**TOWN OF BAY HARBOR ISLANDS
MORRIS N. BROAD COMMUNITY CENTER
1175 95TH STREET
BAY HARBOR ISLANDS, FL 33154**

DEVELOPMENT & REVIEW COMMITTEE MEETING

RESPONSE LETTER TO COMMENTS ROUND #1

PROJECT: BAY HARBOR LUXURY TOWNHOMES

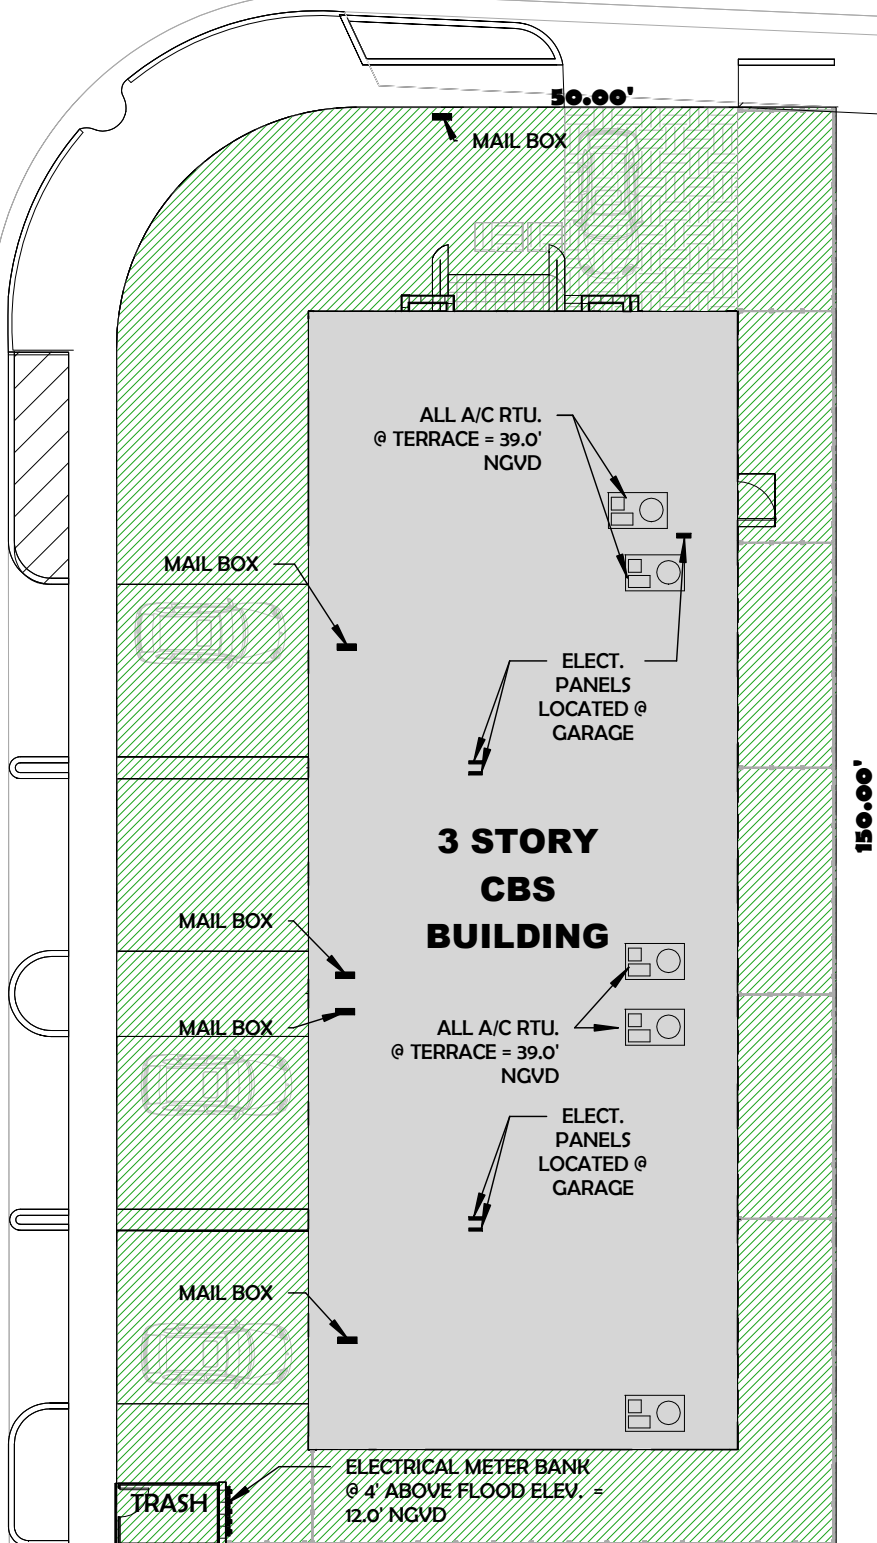
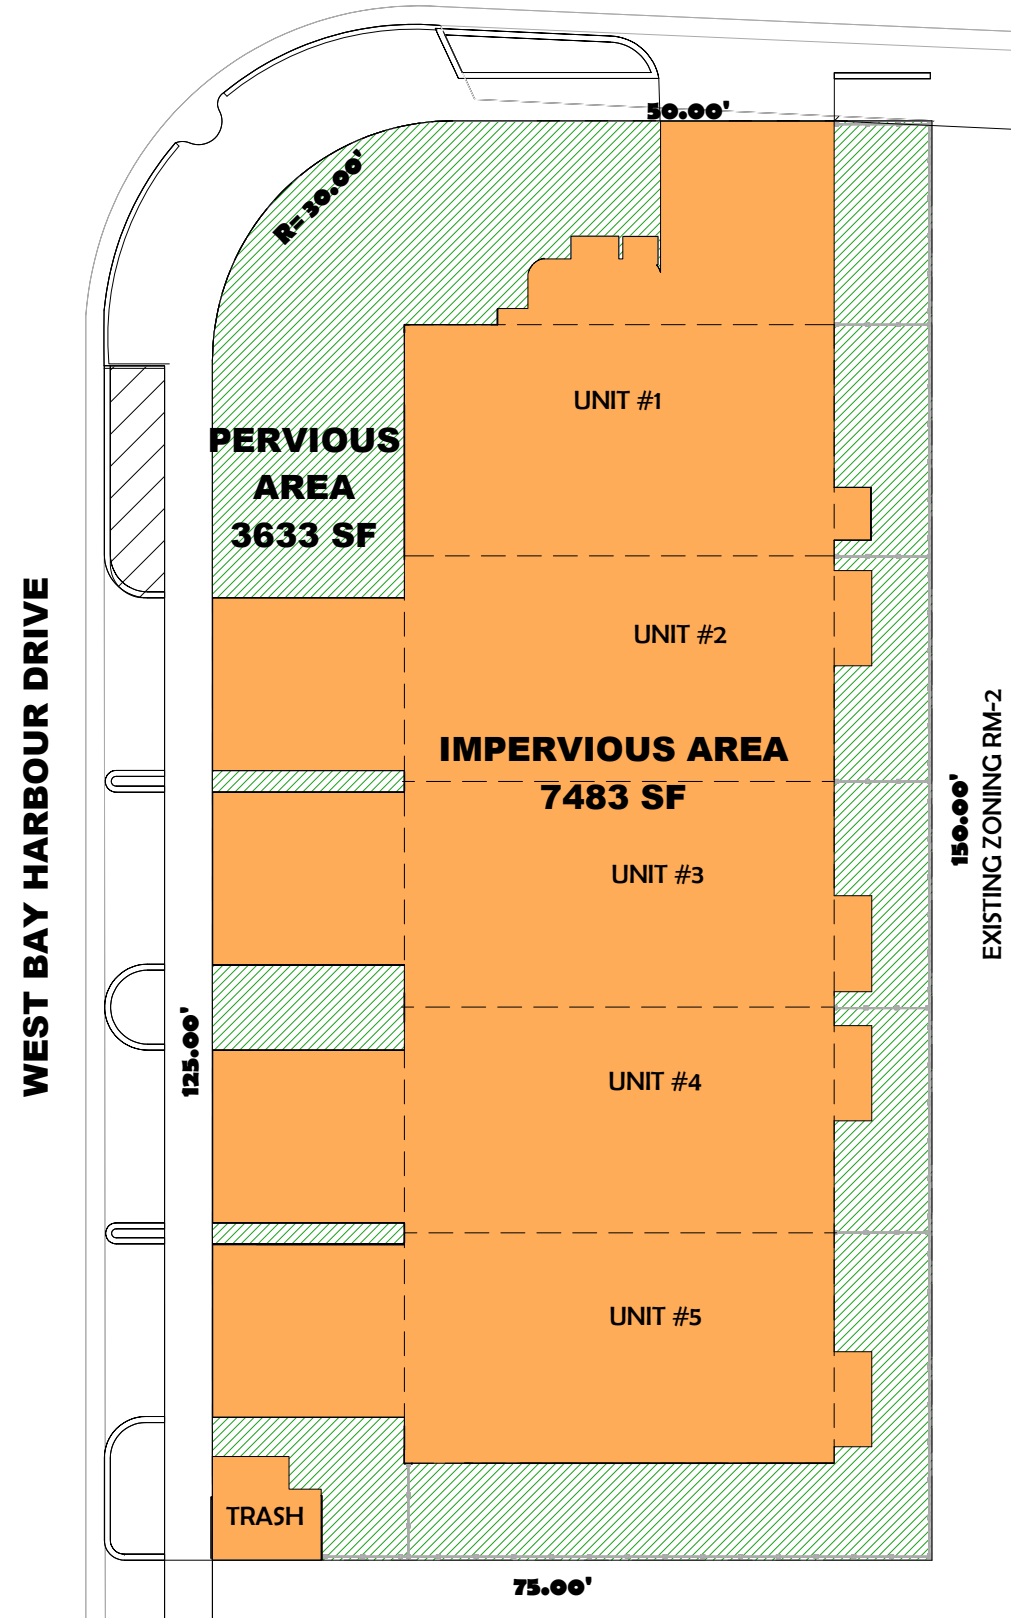
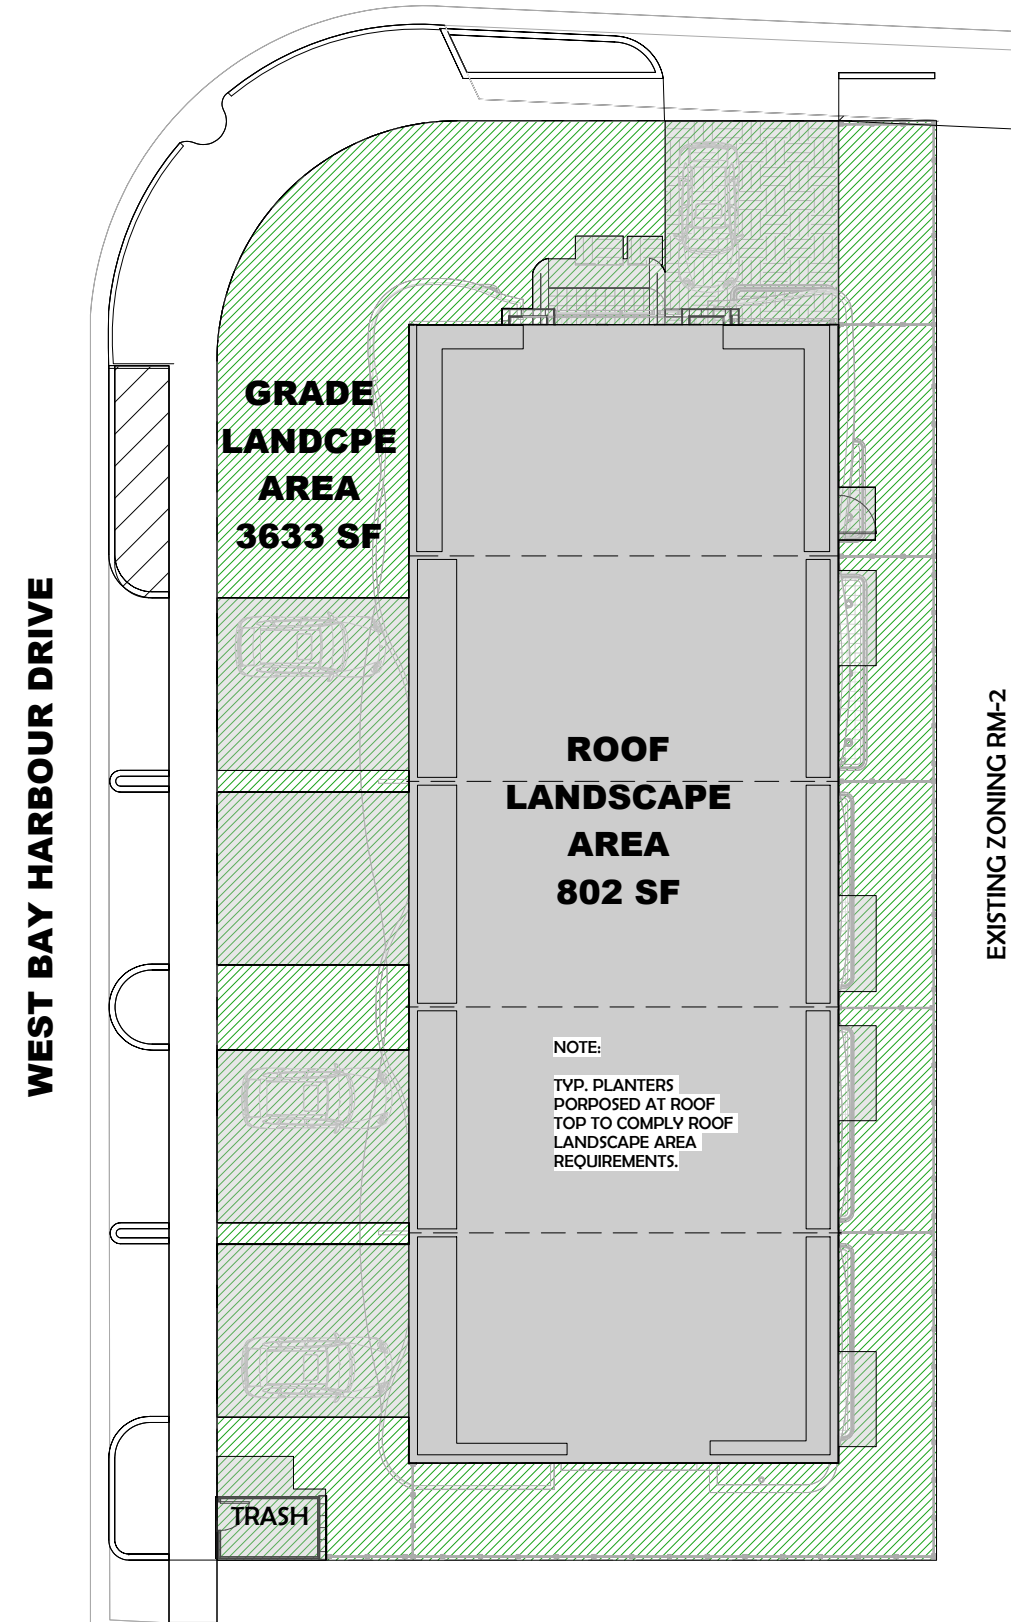
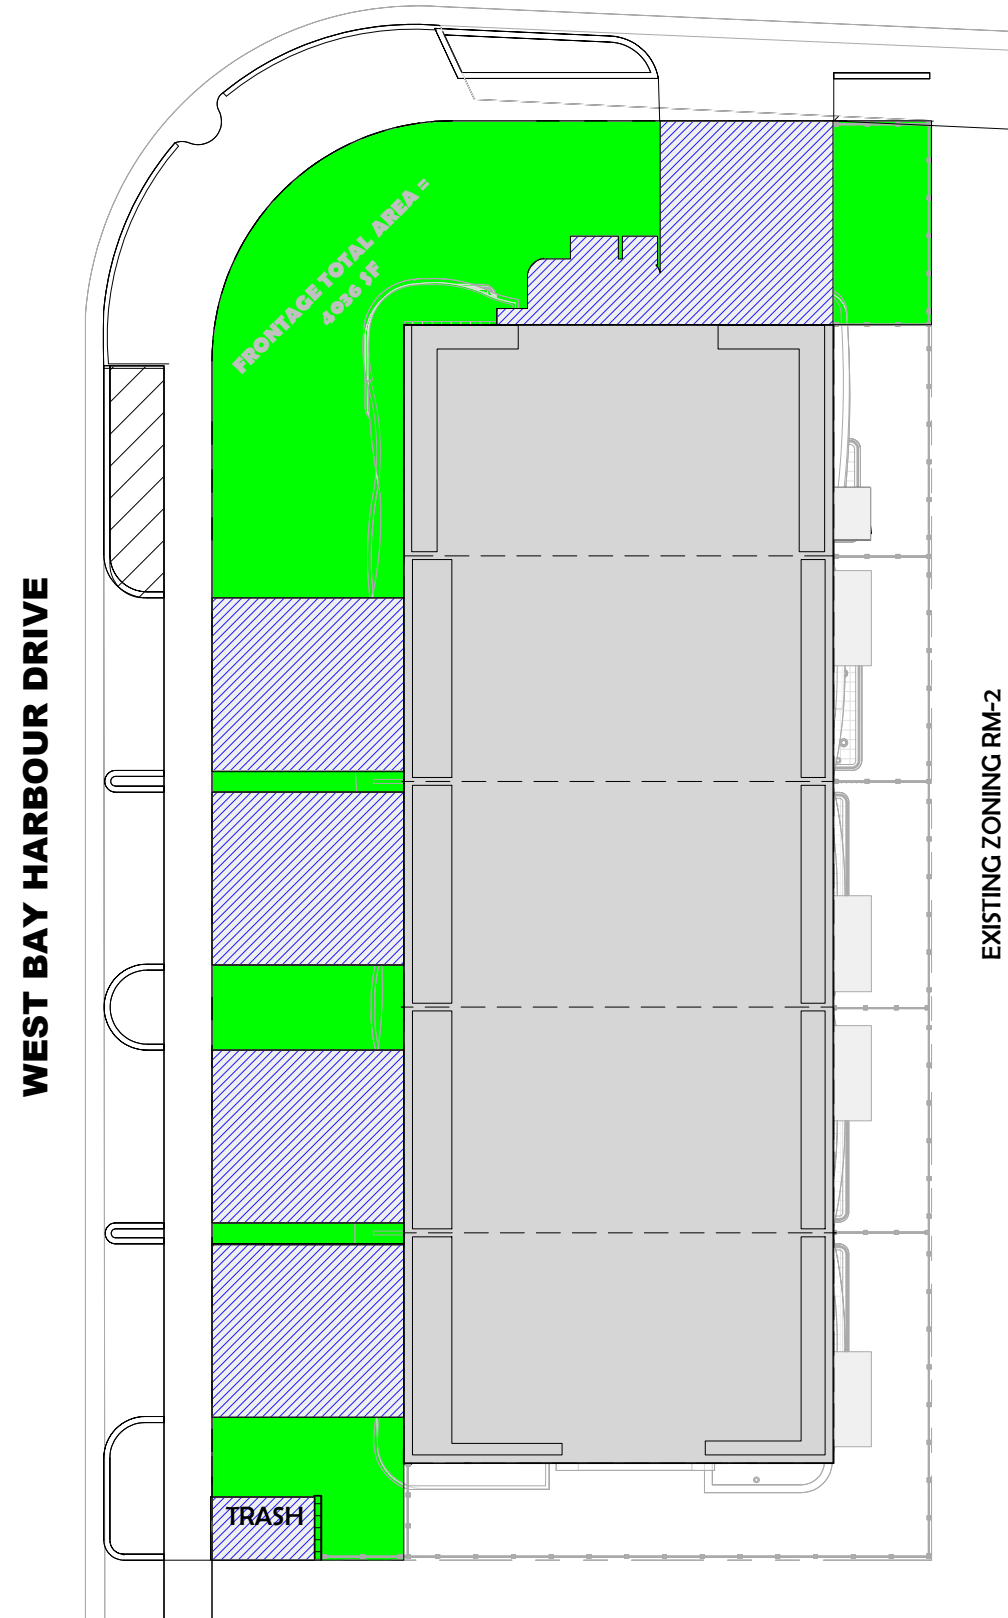
1. SHOW A COMPLETE FLOOD LEGEND (FINISH FLOOR ELEVATION, LOWEST ELEVATION OF EQUIPMENT, FLOOD ZONE, PANEL NUMBER, BASE FLOOD ELEV. HIGHEST CROWN OF ROAD, LOWEST AND HIGHEST ADJACENT GRADE, ETC) AS PER FBC 107.3.5.
R/ COMPLETE FLOOD LEGEND AND NOTES ARE SHOWN IN SHEET A-01

2. PLANS SHOWS ENCLOSURES ON GROUND FLOOR THAT ARE BELOW DFE (BFE + 1 FT). CLARIFY HOW EACH OF THESE AREAS WOULD COMPLY WITH ASCE 24 *DRY OR WET FLOODPROOFING? MATERIALS BELOW BFE)
R/ NOTE REGARDING FLOODPROOFING MATERIALS COMPLYING ASCE 24, SHOWN IN SHEET A-01

1. ON THE GENERAL CODE DATA TABLE, THE FLUM DESIGNATION OF MEDIUM -HIGH DENSITY (6-34 DUA) MUST BE LISTED.
R/ FLUM DESIGNATION SHOWN IN SHEET A-01
2. THE SETBACKS AND HEIGHT REQUIREMENTS TABLE HAS THE FOLLOWING ISSUES:

4. PER SEC. 5-20 AND ADJACENT LAND USE MAP NEEDS TO BE INCLUDED IN THE PLANS SHOWING ALL ADJACENT LAND USES / ZONING DISTRICTS WITHIN A 300 -FOOT RADIUS OF THE SUBJECT PROPERTY.
R/ MAP PROVIDED SEE SHEET A-01

- B) PROVIDE A DETAIL / PLAN SHOWING PERVIOUS IMPERVIOUS AREAS.

R/ KEY PLAN PROVIDED ON SHEET A-01

PERVIOUS AREA KEY PLAN
3633 SF = 32.68% > 2223 SF (20% MIN REQ'D)
